Groundwater Application Review Summary Form

Application # G- 18502

To: Kristopher Byrd, Well Construction and Compliance Section Manager
From: Joel Jeffery, Well Construction Program Coordinator
Subject: Review of Water Right Application G-18502
Date: September 14, 2018

PUBLIC INTEREST REVIEW FOR GROUNDWATER APPLICATIONS

Figure 2. Well Location Map.

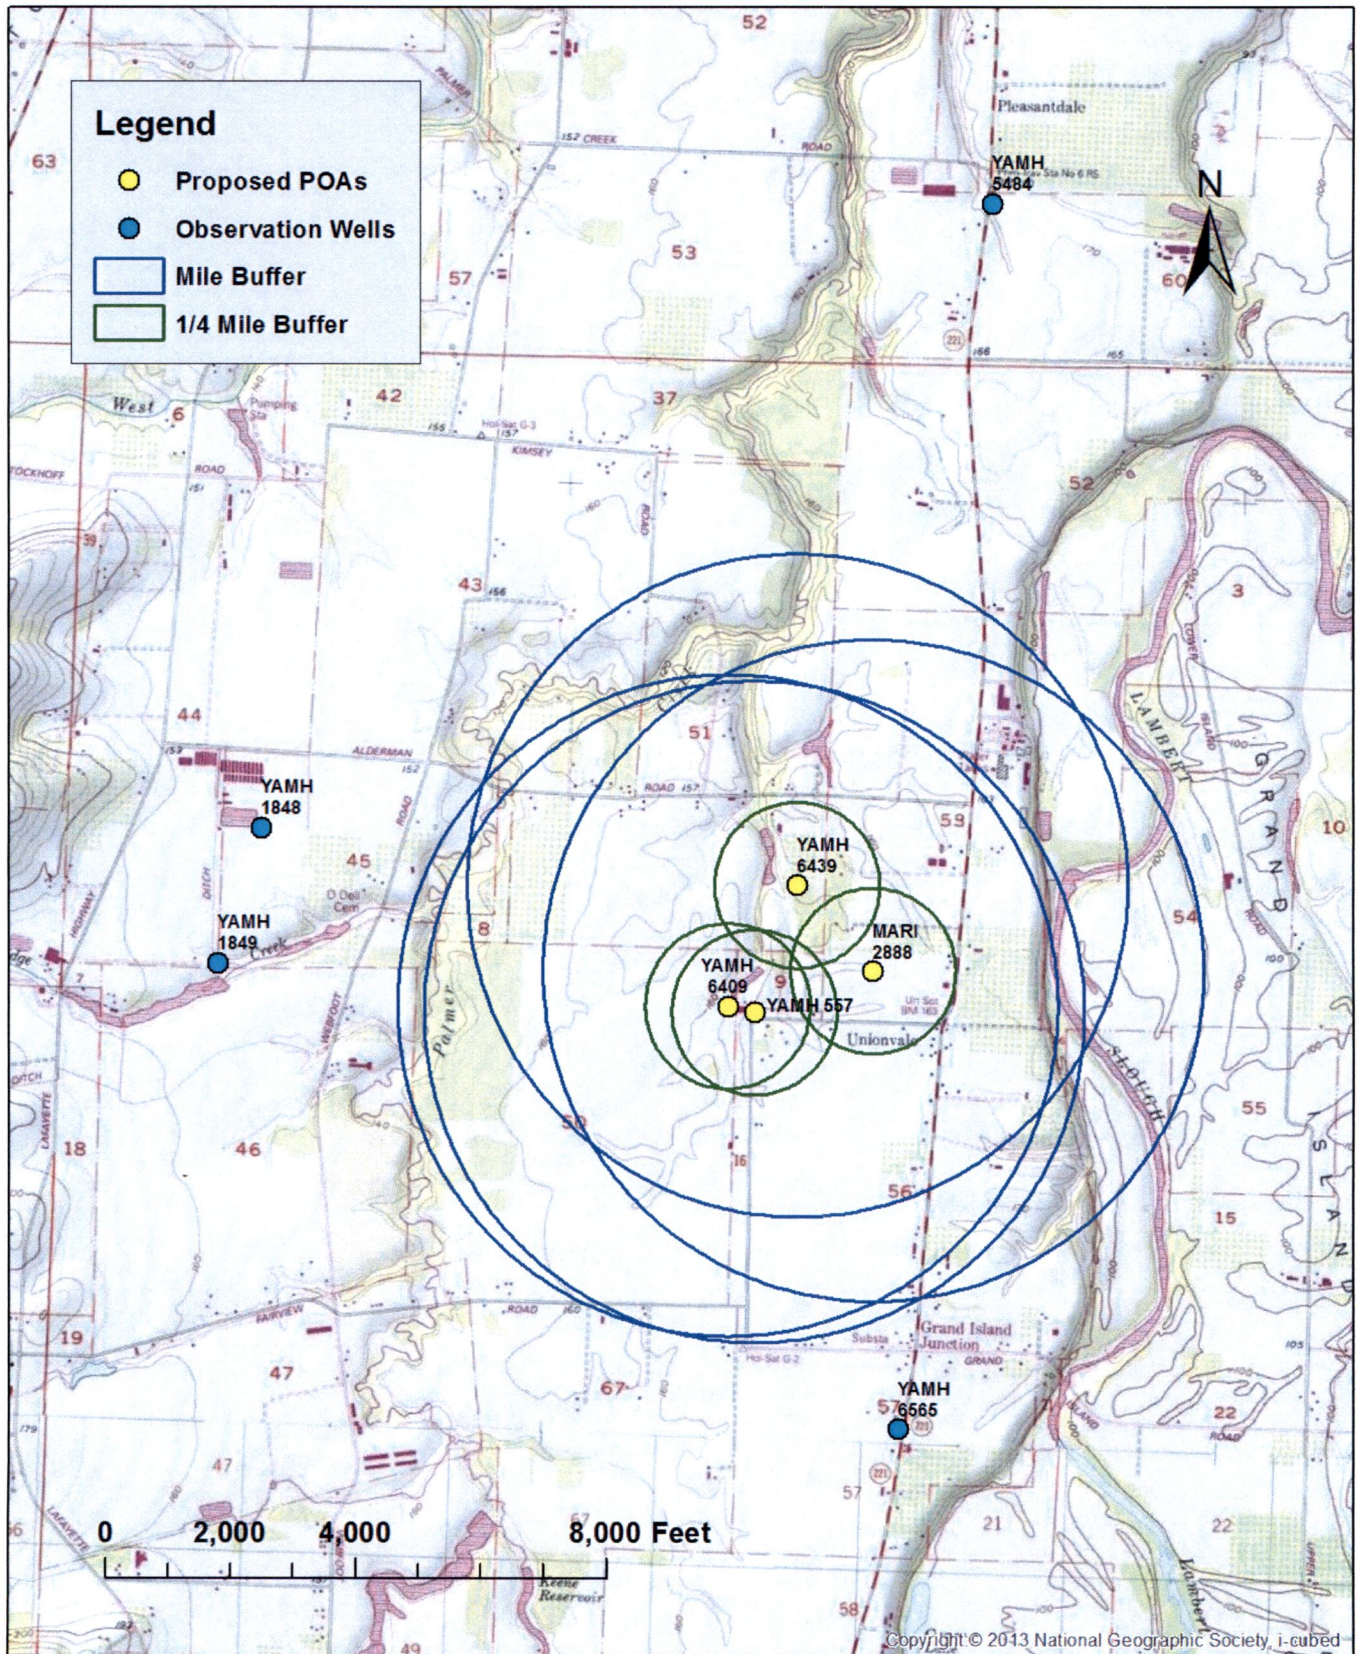
A4. **Comments:** *Application map lists legal location of YAMH 6409 as 210' S, 360' W of NW cor DLC 56. The actual location is 210' S, 360' E of NW cor DLC 56.

Figure 4. Hunt (2003) Analytical Model Parameters and Results for Well 4 to Warner Creek.

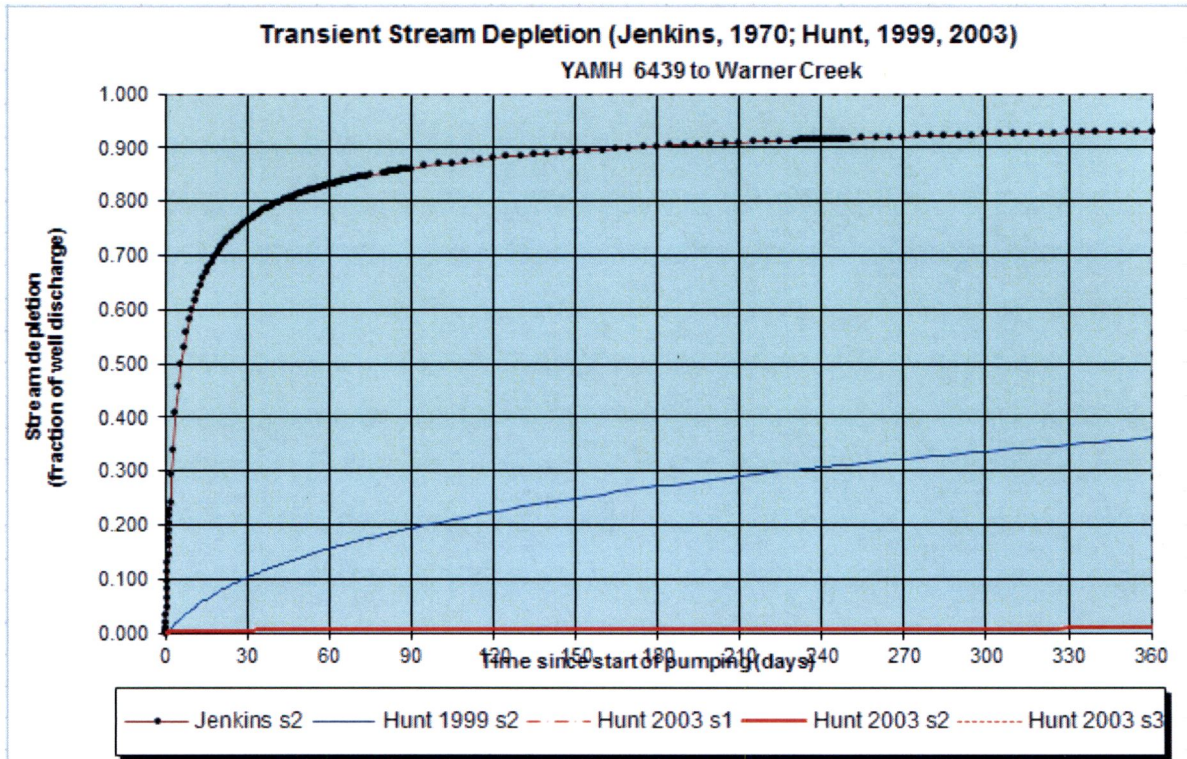
Output for Stream Depletion, Scenario 2 (s2):					Time pump on (pumping duration) = 365 days							
Days	30	60	90	120	150	180	210	240	270	300	330	360
J SD	76.2%	83.0%	86.1%	88.0%	89.2%	90.2%	90.9%	91.5%	92.0%	92.4%	92.7%	93.0%
H SD 1999	10.2%	15.6%	19.4%	22.4%	24.9%	27.1%	29.0%	30.7%	32.2%	33.6%	34.9%	36.1%
H SD 2003	0.52%	0.55%	0.59%	0.62%	0.66%	0.69%	0.73%	0.77%	0.80%	0.84%	0.87%	0.91%
Qw, cfs	4.390	4.390	4.390	4.390	4.390	4.390	4.390	4.390	4.390	4.390	4.390	4.390
H SD 99, cfs	0.449	0.684	0.852	0.984	1.094	1.189	1.273	1.347	1.415	1.476	1.533	1.585
H SD 03, cfs	0.023	0.024	0.026	0.027	0.029	0.030	0.032	0.034	0.035	0.037	0.038	0.040

Parameters:		Scenario 1	Scenario 2	Scenario 3	Units
Net steady pumping rate of well	Qw	4.39	4.39	4.39	cfs
Time pump on (pumping duration)	tpon	365	365	365	days
Perpendicular from well to stream	a	2100	2100	2100	ft
Well depth	d	140	140	140	ft
Aquifer hydraulic conductivity	K	10	10	10	ft/day
Aquifer saturated thickness	b	40	40	40	ft
Aquifer transmissivity	T	400	400	400	ft ² /day
Aquifer storativity or specific yield	S	0.0001	0.0005	0.001	
Aquitard vertical hydraulic conductivity	Kva	0.001	0.005	0.01	ft/day
Aquitard saturated thickness	ba	15	15	15	ft
Aquitard thickness below stream	babs	10	10	10	ft
Aquitard porosity	n	0.2	0.2	0.2	
Stream width	ws	50	50	50	ft
Streambed conductance (lambda)	sbc	0.005000	0.025000	0.050000	ft/day
Stream depletion factor	sdf	1.102500	5.512500	11.025000	days
Streambed factor	sbf	0.026250	0.131250	0.262500	
input #1 for Hunt's Q_4 function	t'	0.907029	0.181406	0.090703	
input #2 for Hunt's Q_4 function	K'	0.735000	3.675000	7.350000

Figure 5. Hunt (2003) Analytical Model Parameters and Results for Well 4 to Palmer Creek.

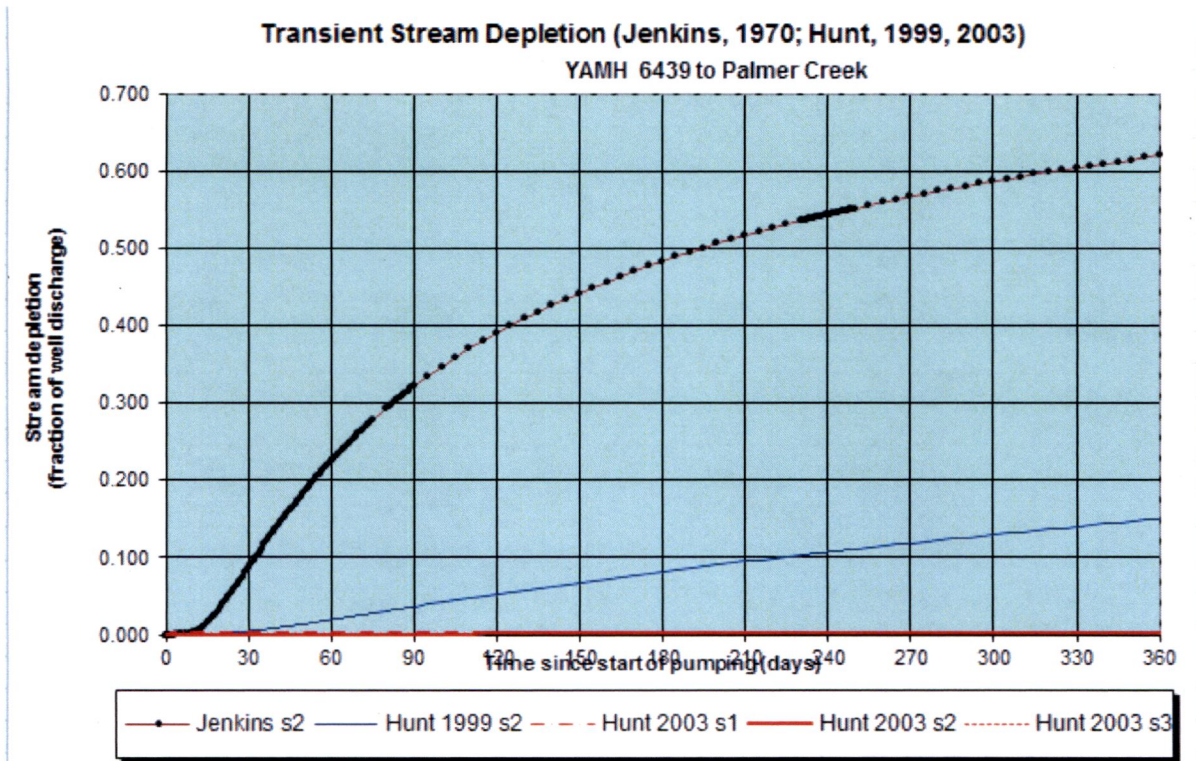
Output for Stream Depletion, Scenario 2 (s2):					Time pump on (pumping duration) = 365 days							
Days	30	60	90	120	150	180	210	240	270	300	330	360
J SD	8.6%	22.4%	32.1%	39.0%	44.2%	48.3%	51.6%	54.3%	56.7%	58.7%	60.4%	62.0%
H SD 1999	0.5%	1.9%	3.6%	5.2%	6.8%	8.2%	9.5%	10.7%	11.9%	13.0%	14.0%	15.0%
H SD 2003	0.06%	0.09%	0.11%	0.13%	0.14%	0.16%	0.18%	0.20%	0.22%	0.24%	0.26%	0.28%
Qw, cfs	4.390	4.390	4.390	4.390	4.390	4.390	4.390	4.390	4.390	4.390	4.390	4.390
H SD 99, cfs	0.020	0.085	0.159	0.230	0.297	0.359	0.417	0.471	0.522	0.570	0.615	0.658
H SD 03, cfs	0.003	0.004	0.005	0.005	0.006	0.007	0.008	0.009	0.009	0.010	0.011	0.012

Parameters:		Scenario 1	Scenario 2	Scenario 3	Units
Net steady pumping rate of well	Qw	4.39	4.39	4.39	cfs
Time pump on (pumping duration)	tpon	365	365	365	days
Perpendicular from well to stream	a	3765	3765	3765	ft
Well depth	d	140	140	140	ft
Aquifer hydraulic conductivity	K	10	10	10	ft/day
Aquifer saturated thickness	b	40	40	40	ft
Aquifer transmissivity	T	400	400	400	ft*ft/day
Aquifer storativity or specific yield	S	0.0001	0.005	0.001	
Aquitard vertical hydraulic conductivity	Kva	0.001	0.005	0.01	ft/day
Aquitard saturated thickness	ba	10	10	10	ft
Aquitard thickness below stream	babs	5	5	5	ft
Aquitard porosity	n	0.2	0.2	0.2	
Stream width	ws	50	50	50	ft
Streambed conductance (lambda)	sbc	0.010000	0.050000	0.100000	ft/day
Stream depletion factor	sdf	3.543806	177.190313	35.438063	days
Streambed factor	sbf	0.094125	0.470625	0.941250	
input #1 for Hunt's Q_4 function	t'	0.282182	0.005644	0.028218	
input #2 for Hunt's Q_4 function	K'	3.543806	17.719031	35.438063
